CITY OF KELOWNA

MEMORANDUM

Date: June 6, 2016
File No.: Z16-0022
To: Community Planning (TB)
From: Development Engineering Manager(SM)
Subject: 815 Rose Ave *REVISED*

RU6 to RM1

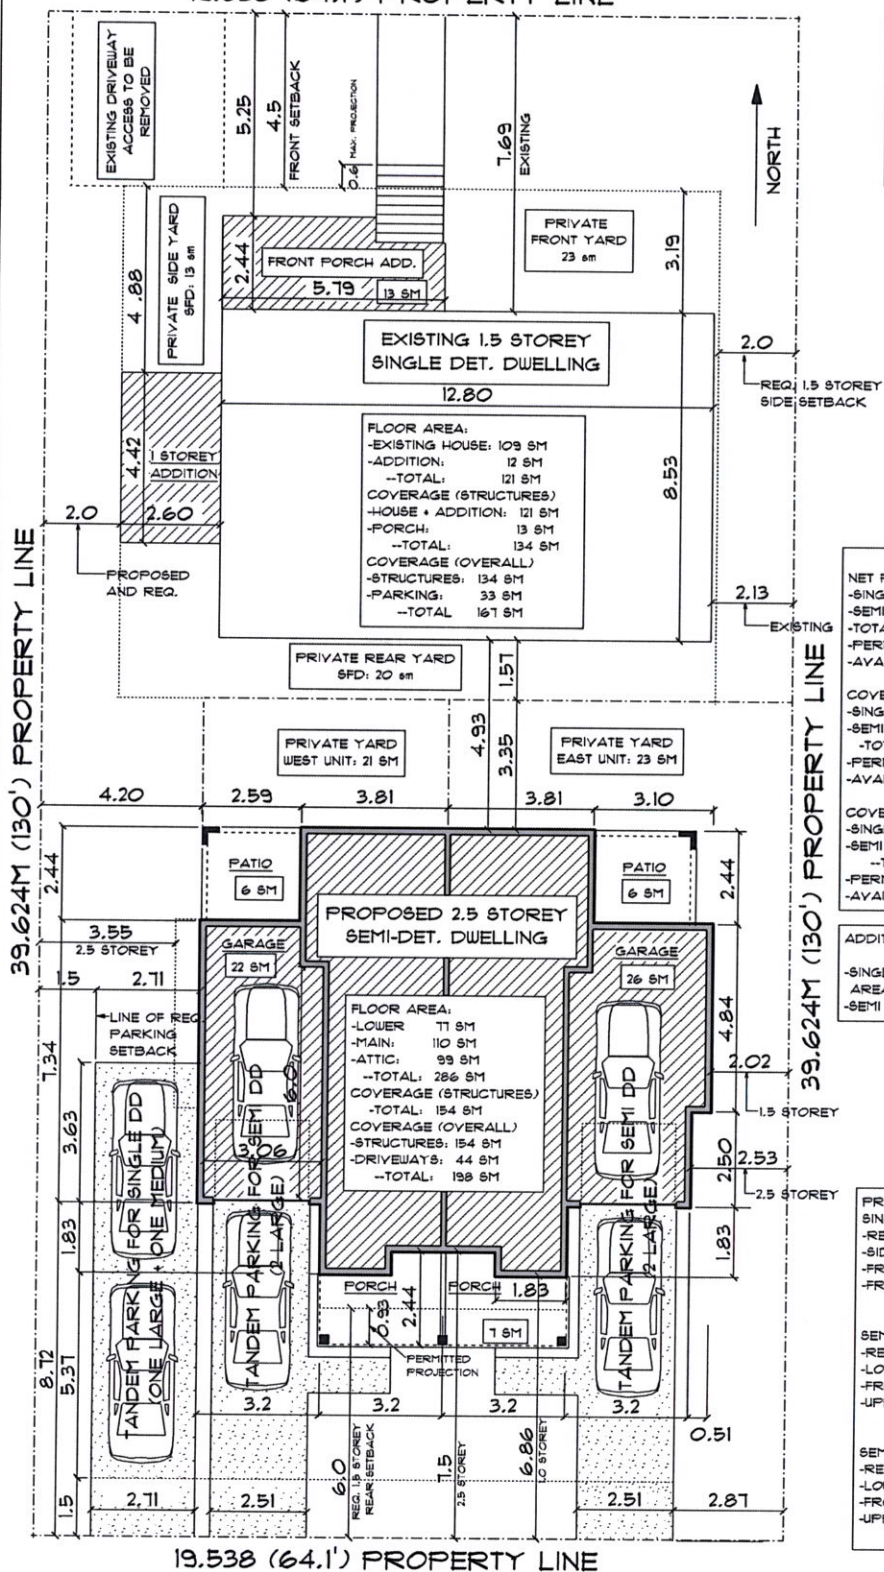
- (a) Grant Statutory Rights of Way if required for utility services.
- (b) Provide a 5.0m road reserve along the full frontage of Rose Avenue.
- (c) If any road dedication or closure affects lands encumbered by a Utility right-of-way (such as Hydro, Telus, Gas, etc.) please obtain the approval of the utility. Any works required by the utility as a consequence of the road dedication or closure must be incorporated in the construction drawings submitted to the City's Development Manager

Direct the roof drains into on-site rock pits or splash pads.
Access is permitted from the lane only.
